REPORT OF PRELIMINARY GEOTECHNICAL INVESTIGATION

**MORROW RESIDENCE
8460 EL PASEO GRANDE
LA JOLLA, CALIFORNIA**

Subject: Response to DSD-Geology Review Comments, Project Issues Report 1113364, dated August 7, 2024, Morrow Residence, 8460 El Paseo Grande, San Diego, California

SITE PLAN AND GEOTECHNICAL MAP

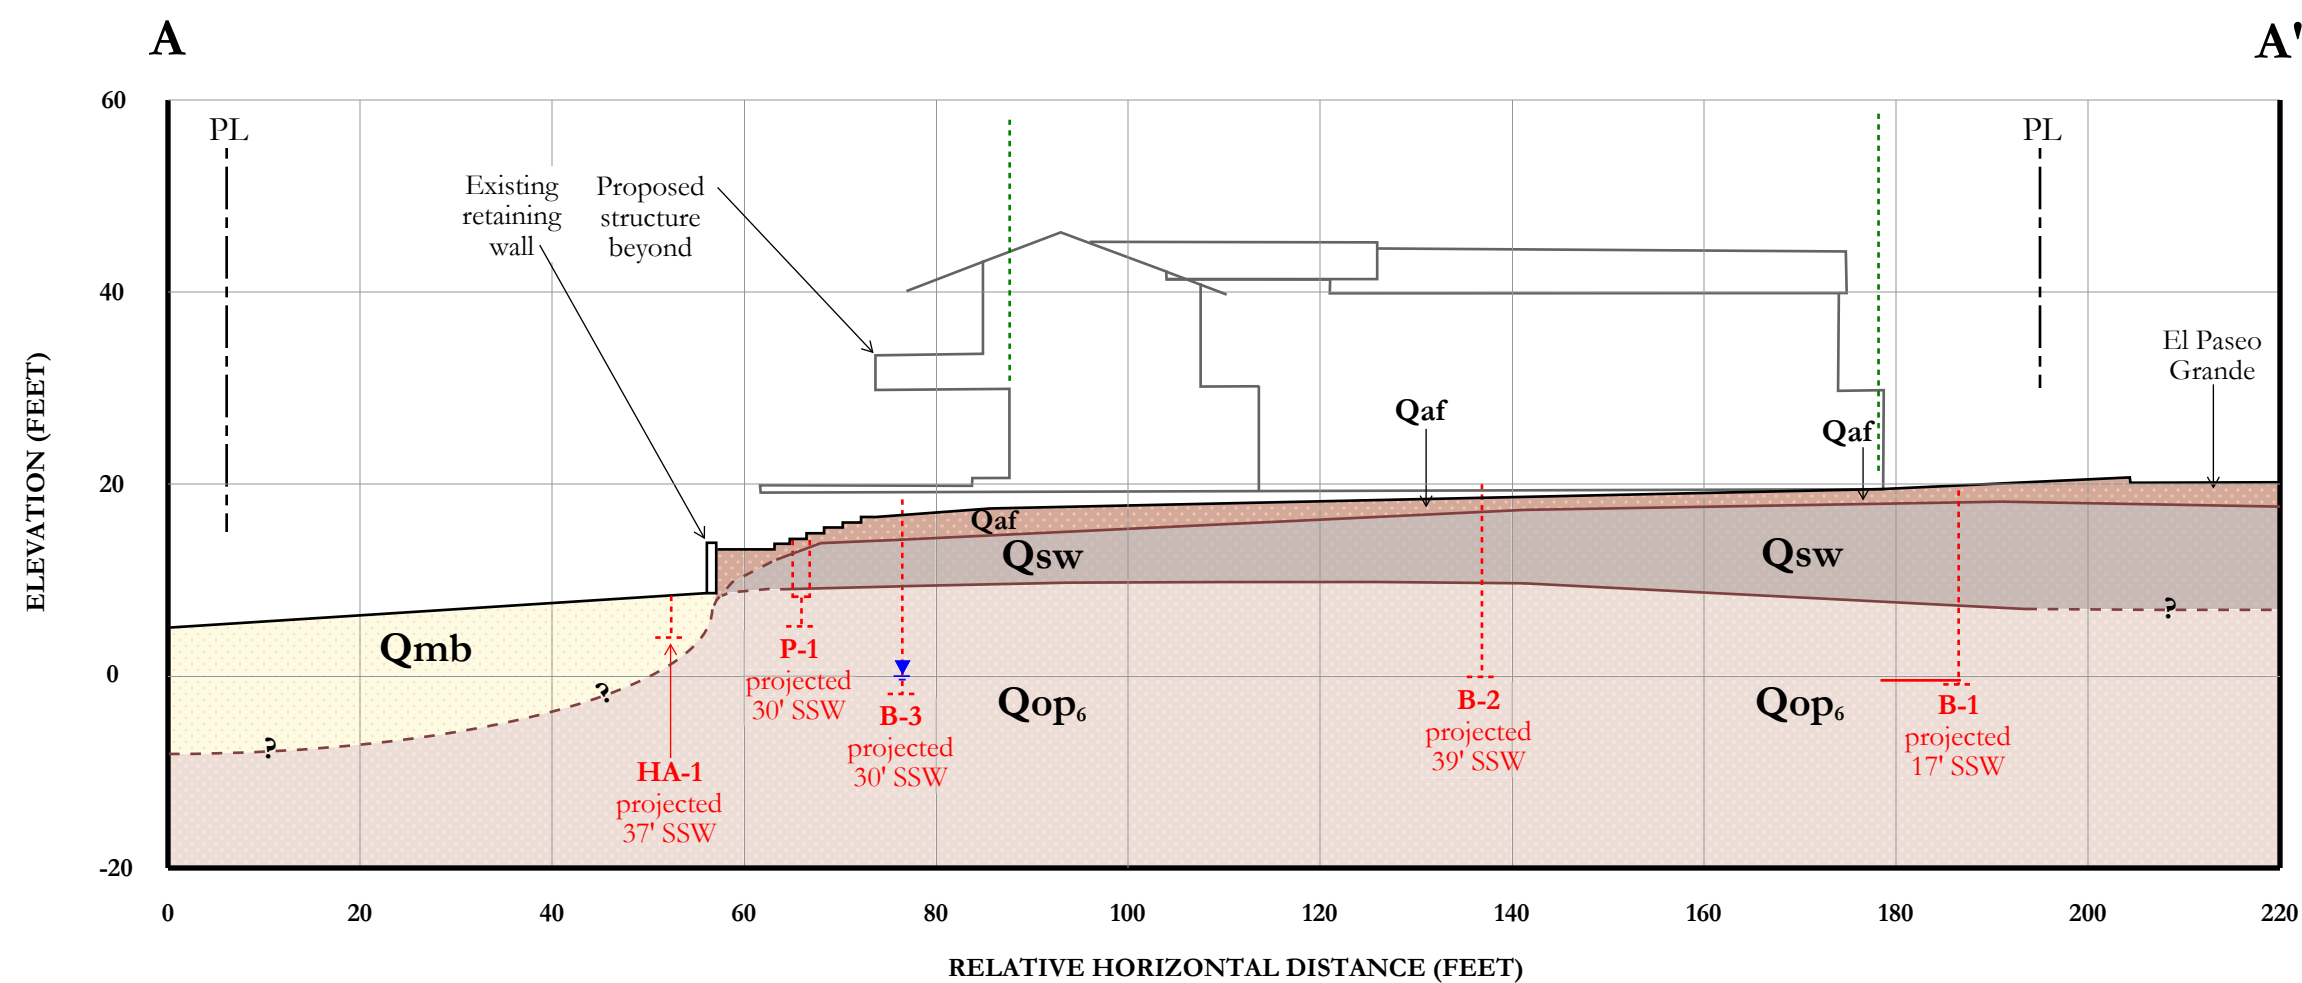
City Comment 00024: The geotechnical investigation report must update geologic/geotechnical map and geologic cross-sections with the proposed new development and building locations.

City Comment 00025: Circumscribe the limits of anticipated remedial grading on the geologic/geotechnical map to delineate the proposed footprint of the project.

CWE Response: Plate No. 1 of this report presents an updated site plan and geotechnical map that shows the distribution of fill and site geology, which circumscribes the limits of recommended remedial grading, and which depicts the proposed construction. Updated geologic cross sections are presented on Plate Nos 2-4 of this report.

CWE Response: The limits of anticipated remedial grading are circumscribed on the revised Site Plan and Geotechnical map included as Plate No. 1 of this report.
